Addendum to
**PowerPC™ 601 RISC Microprocessor User's
Manual**

This addendum describes additions and corrections to the *PowerPC 601 RISC Microprocessor User's Manual*. For convenience, this information is organized according to the chapters in the user's manual; however, there is no attempt to provide a comprehensive list of text that is affected by this information. These changes will be incorporated in the first revision of the user's manual.

Figure 1-6. MPC601 Signal Groups

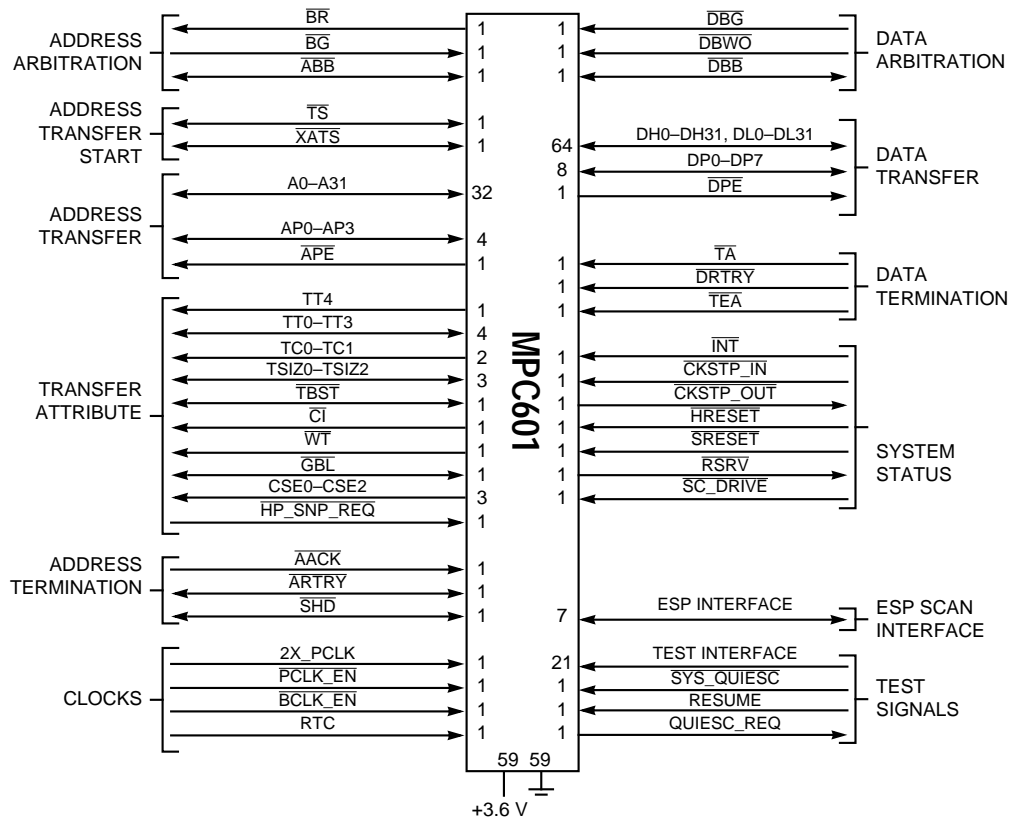
- 1.1.5 In the first sentence in this section replace Terabyte with Petabyte.
- 1.3.8.4 Replace Figure 1-6 with the following:

Figure 2-1. Programming Model—Registers

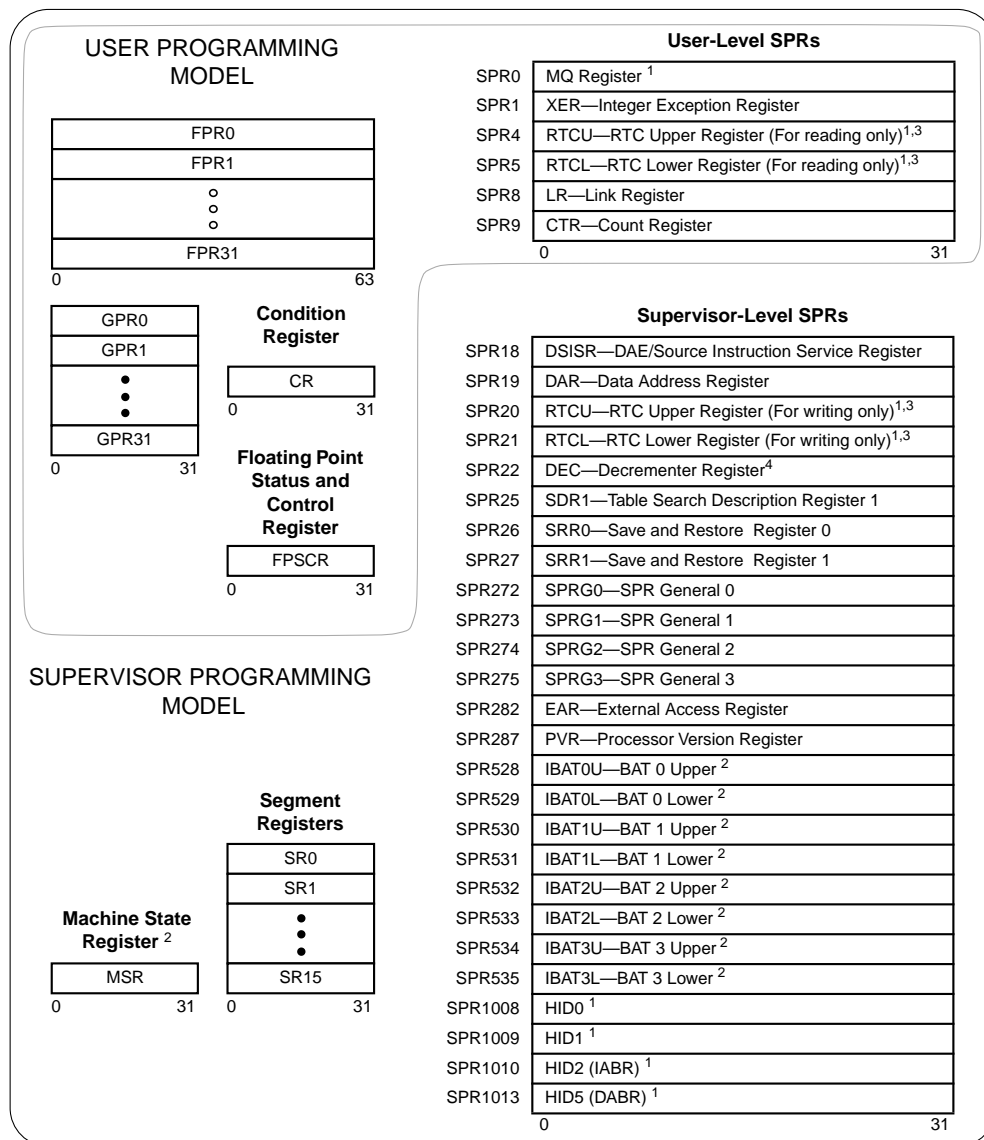
- 2.1 Replace Figure 2-1 with the following:

Figure 7-1. Pipelined Execution Unit

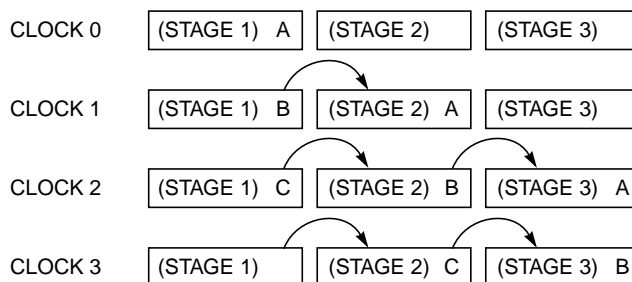
- 7.1 Replace Figure 7-1 with the following:

Figure 8-6. Generation of Bus Transactions—Logical Bus Clock = 1/2 P_CLK

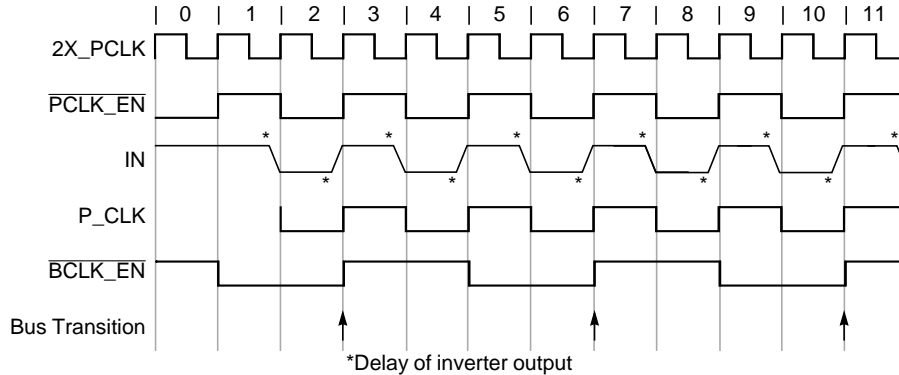
8.2.12.3 Replace Figure 8-6 with the following:

Figure 9-10. Normal Single-Beat Read Termination

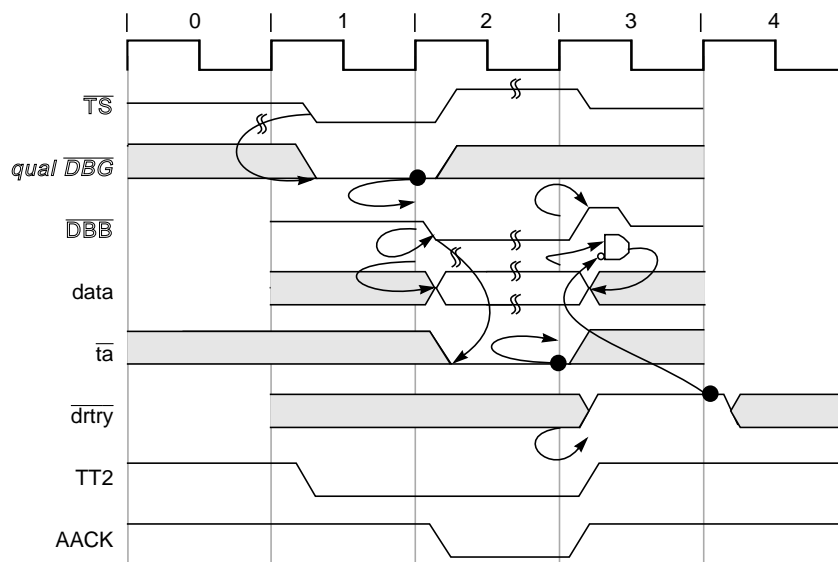
- 9.4.3.1 Replace Figure 9-10 with the following:

Figure 9-11. Normal Single-Beat Write Termination

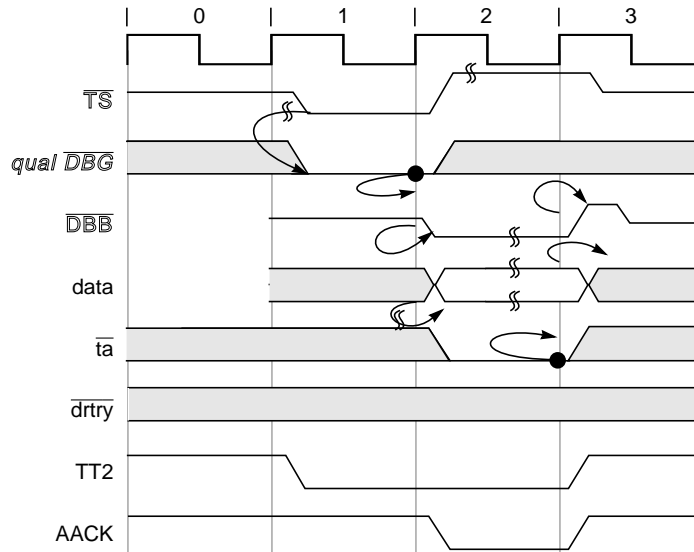
Replace Figure 9-11 with the following:
